Economic Commission for Europe**Inland Transport Committee****World Forum for Harmonization of Vehicle Regulations****Working Party on Passive Safety****Sixty-fourth session**

UN Regulation No. 129 (Enhanced Child Restraint Systems)**Proposal for Supplement 5 to the 02 series of amendments
and Supplement 2 to the 03 series of amendments to UN
Regulation No. 129****Submitted by the expert from the European Association of Automotive
Suppliers***

I. Proposal

Figure 2A

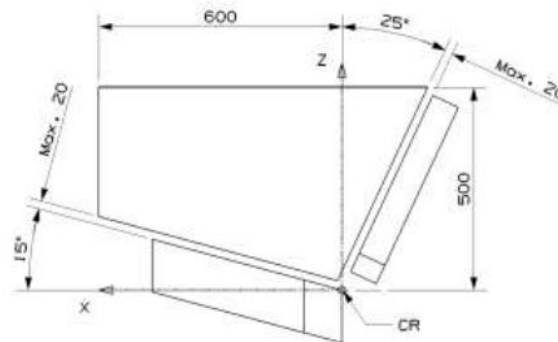
Paragraph 1, Figure 2, shall be deleted

Insert new figures 2A and 2b, to read:

Door panel geometry for testing integral ECRS with ISOFIX – side view (tolerance general: ± 2 mm and ± 1 degree)

This door panel shall be used when the Integral ECRS under test is installed with ISOFIX.

Figure 2B

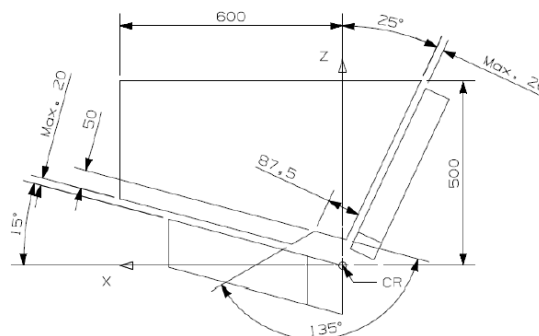
Door panel geometry for testing non-integral ECRS – side view (tolerance general: ± 2 mm and ± 1 degree)

This door panel shall be used when the ECRS under test is installed with the adult seat belt.

Tests to extend the type-approval of Integral ISOFIX ECRS may also use this door, provided it was used for the original type-approval.
